1 ADDENDUM #3

Client
**PEI Department of Transportation
 Infrastructure and Energy**

Project Title
**Queens County Depot
 Phase 5b**

Drawing Number:
SK-03

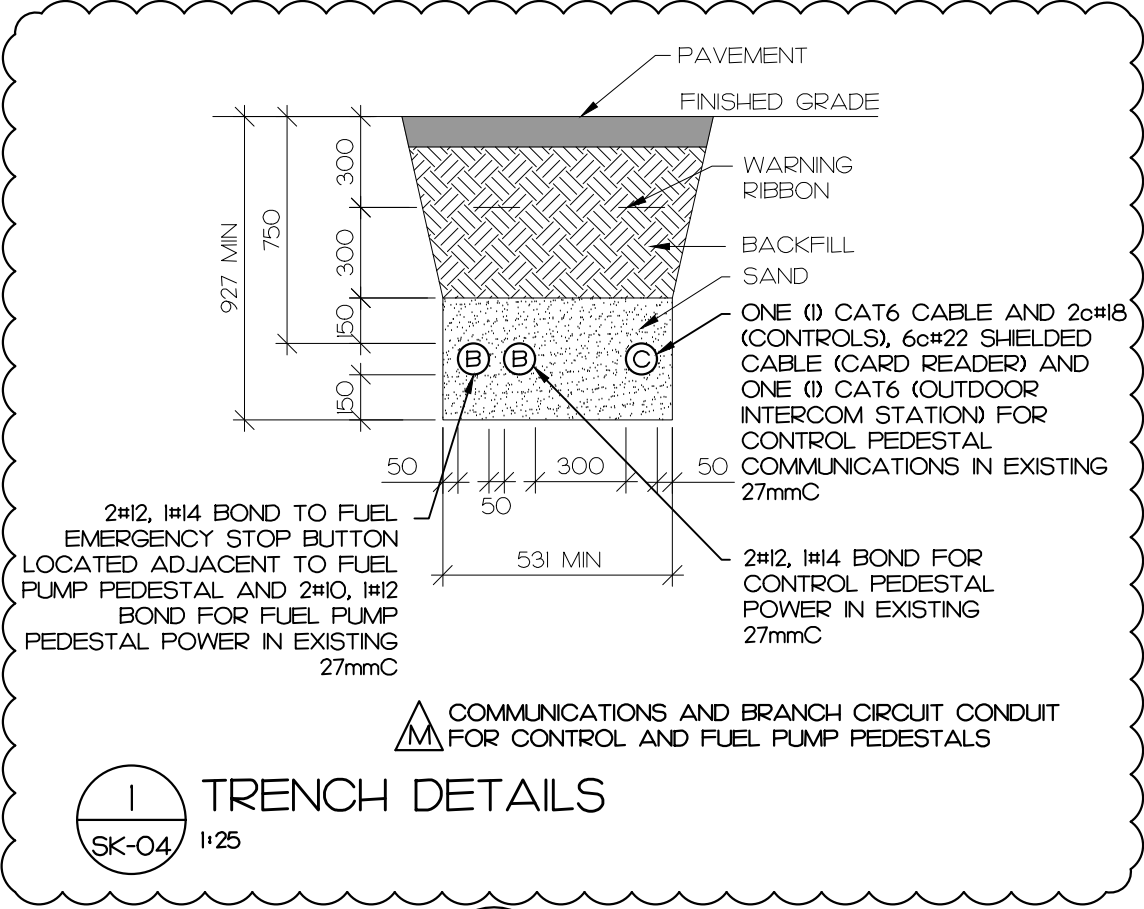
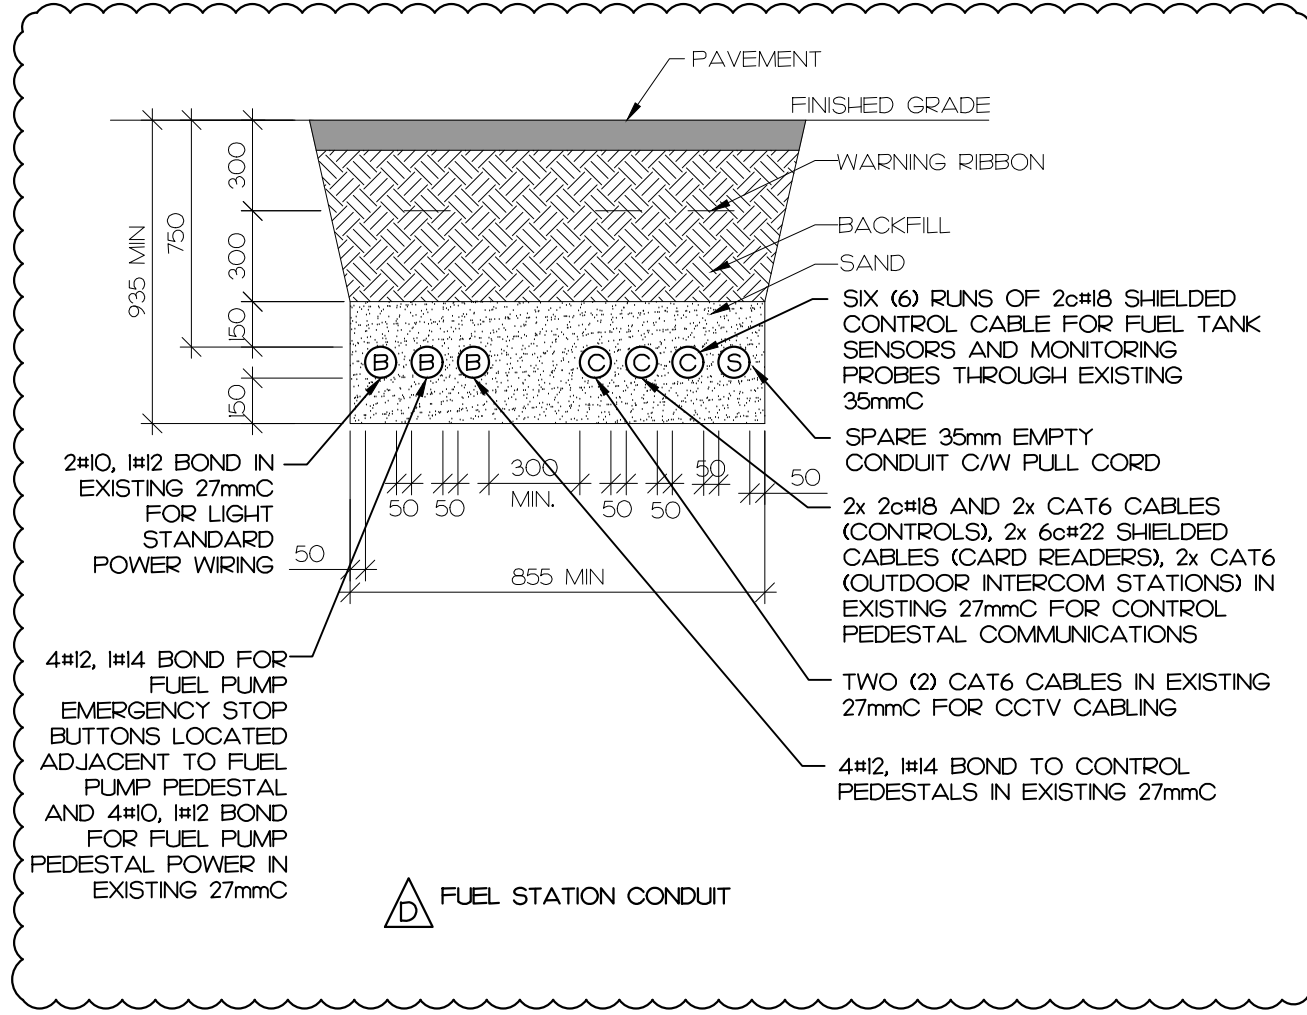
- .1 Reference Detail 1:
 - .1 Clarification: Find attached and forming part of this addendum sketch SK-03 as a clarification of pipe routing in the boiler room

Sheet Title
**Heating Floor Plan
 Updated Boiler Piping Schematic**
